**ADDENDUM NO. 1**  
**For**  
**18-0057-UT MS WRF Blend Tank Mixer**

**ADDENDUM #01 - Responses to Bidder Questions      09/28/2020**

MS WRF BLEND TANK  
MIXER PROJECT  
SLUDGE TANK PLAN AND SECTION

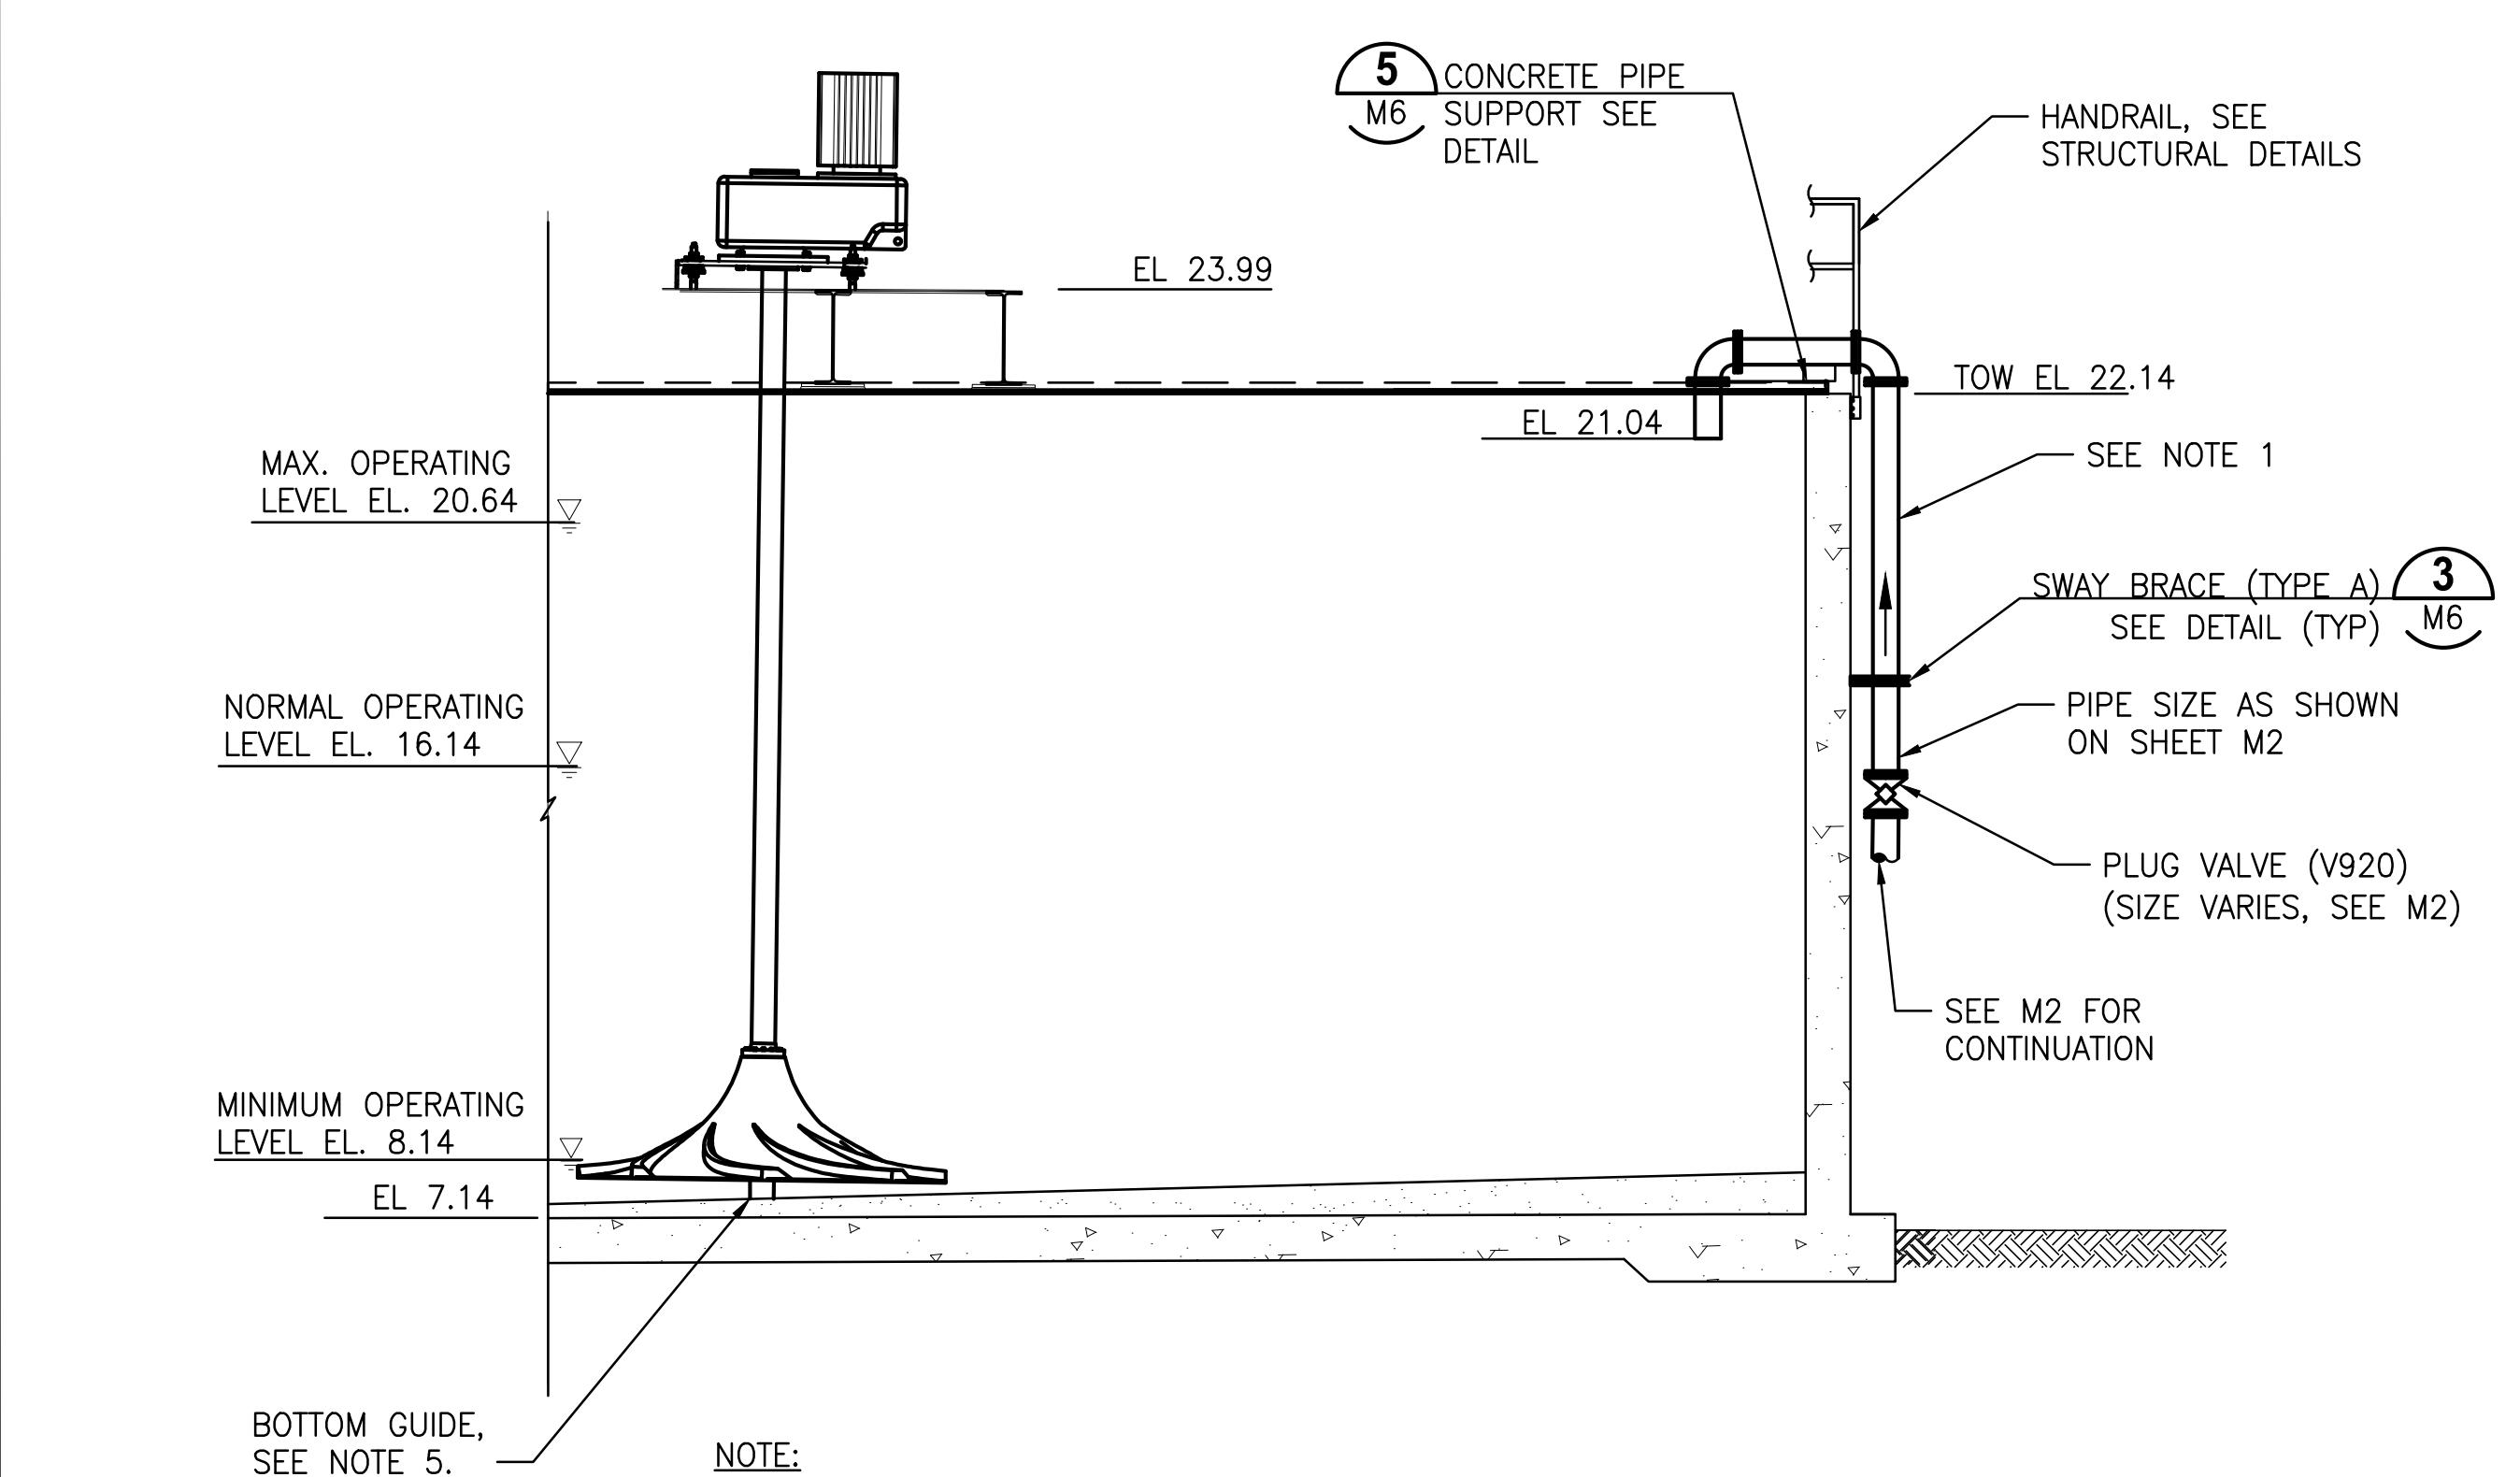
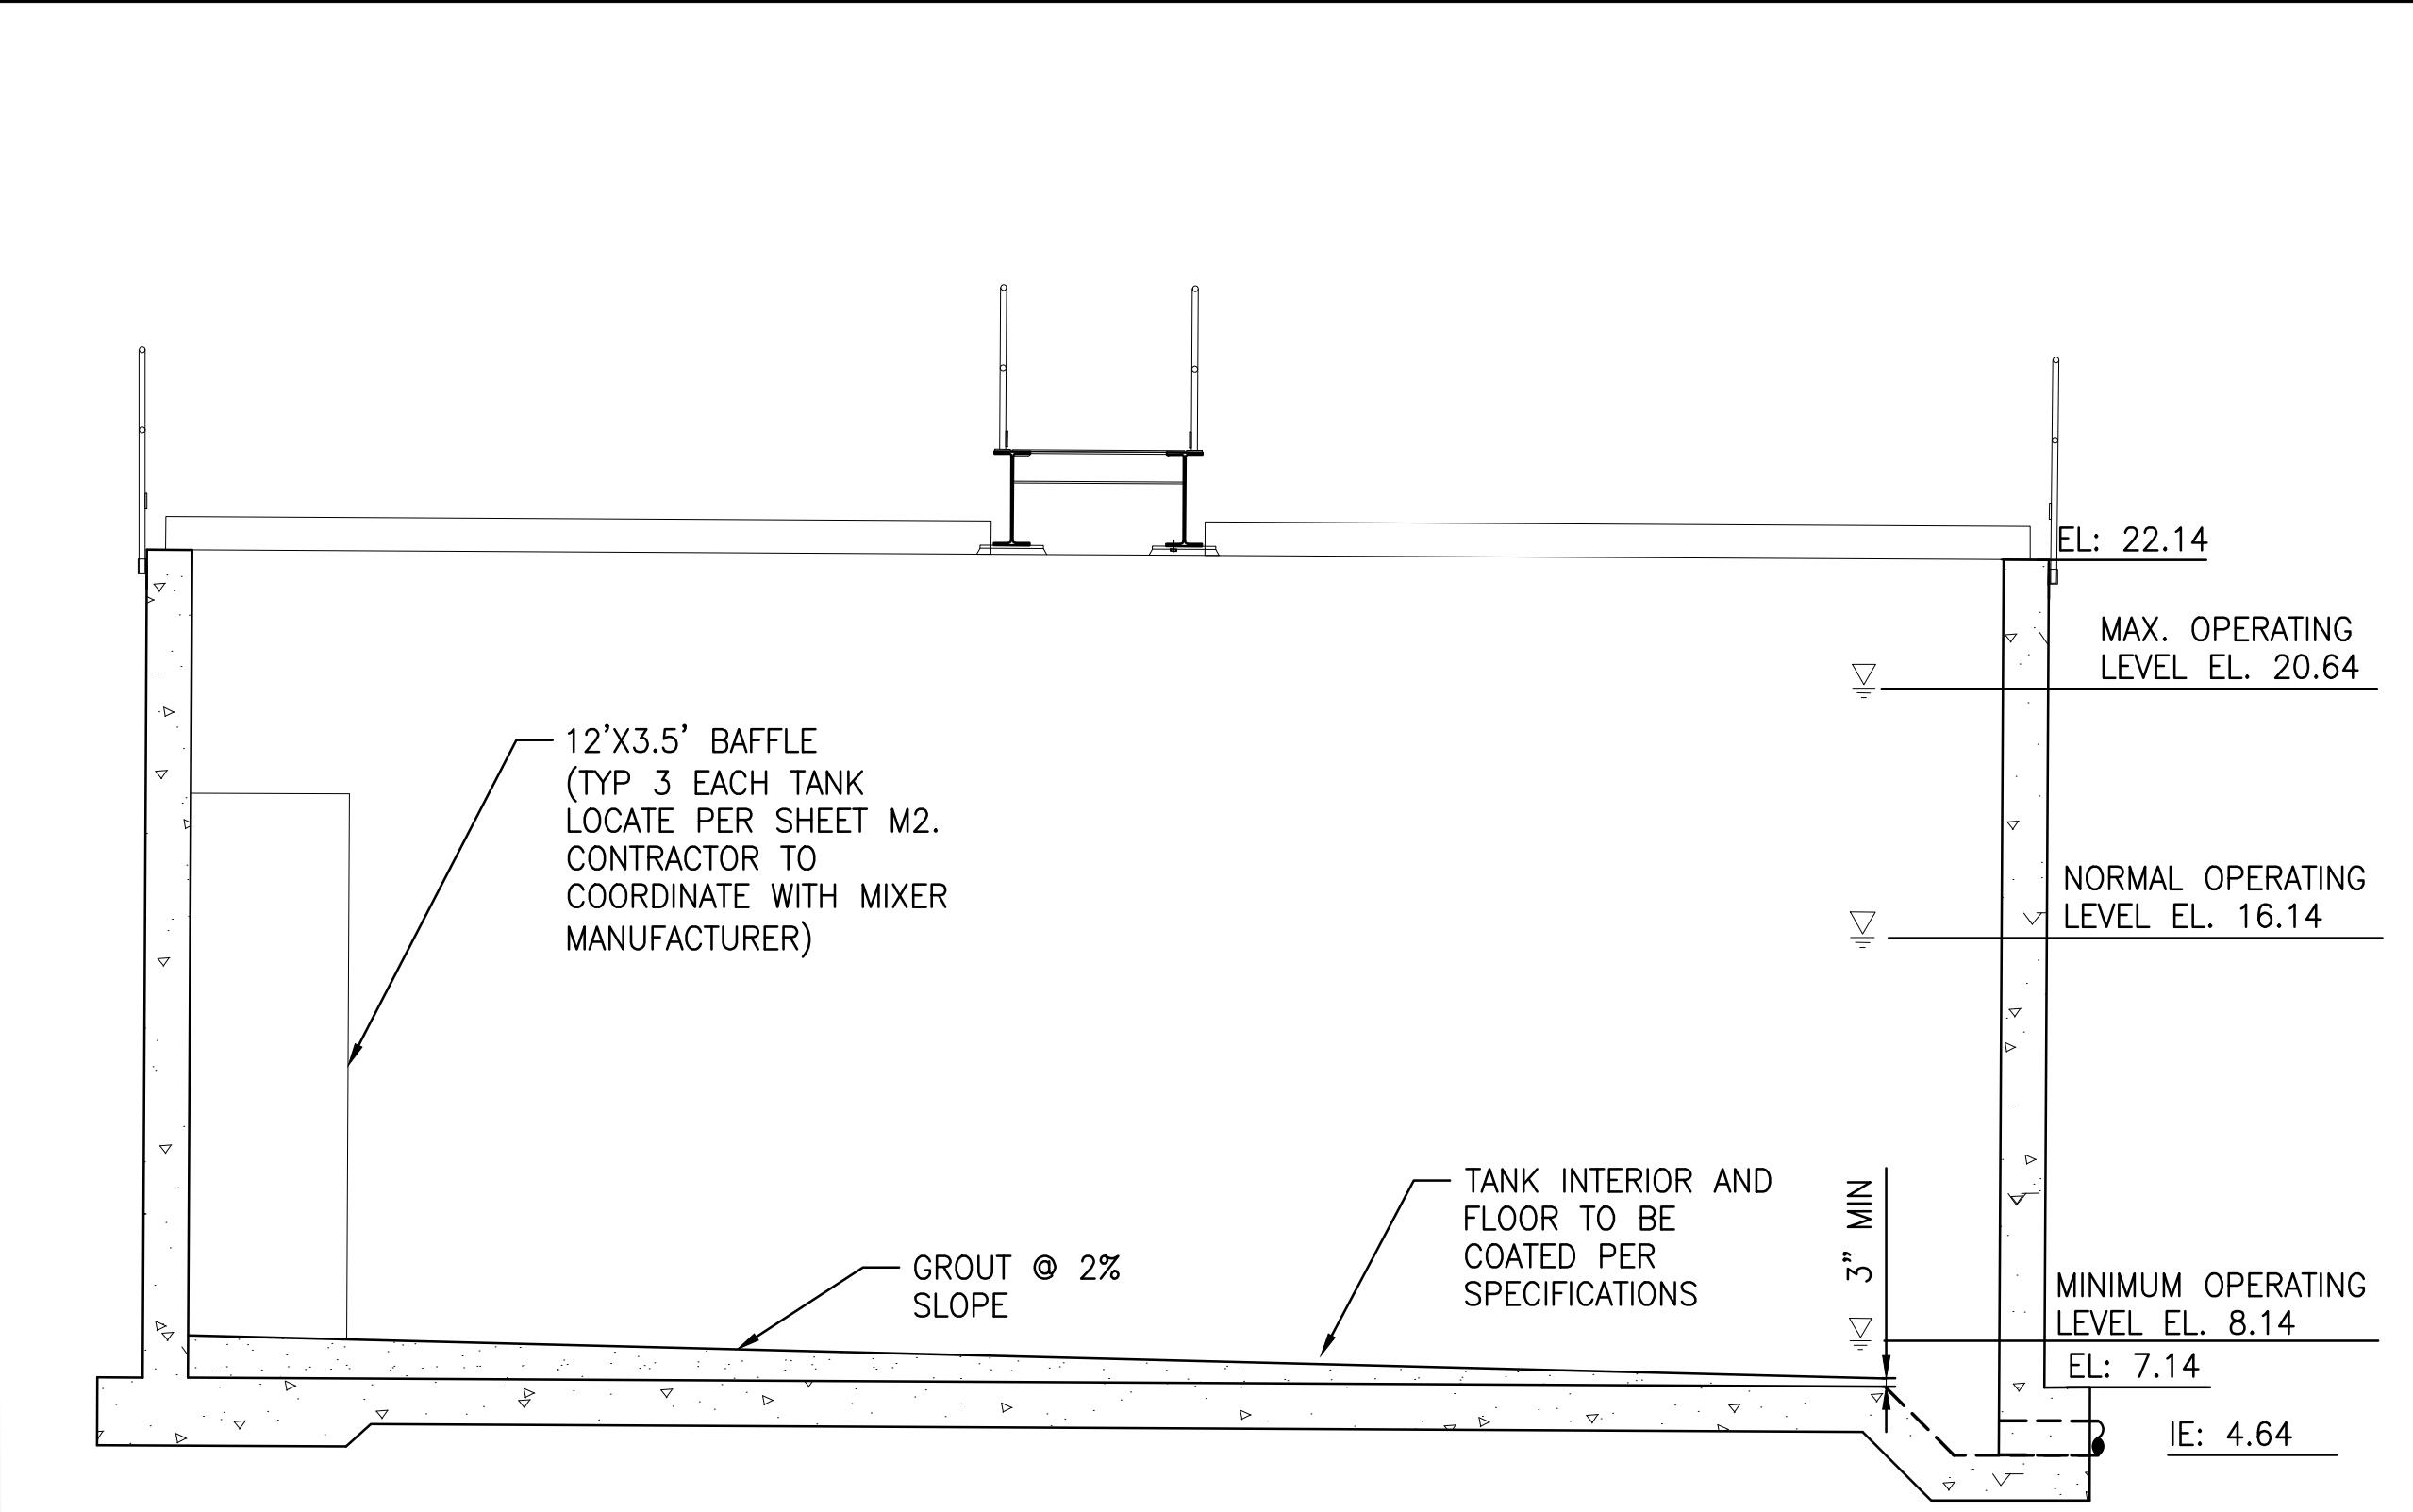
Question 1: A) The scale given on mechanical drawings (M1 to M9) seems to be wrong. The given dimensions on mechanical drawings don't match with the scale.

- a. The listed scales on Sheet M-3 (3/8"=1'-0") are dependent on the Drawings being a Full-Scale / Full Size 22" x 34" set. Confirm scaling on Sheet M-3.
- b. The Plan view on Sheet M-4 is herein revised to depict the correct scale and Tank Diameter. These sheets were intended for referencing elevations.

△ ADDENDUM #1 ADJUSTED SCALE  
REVISION BY DATE
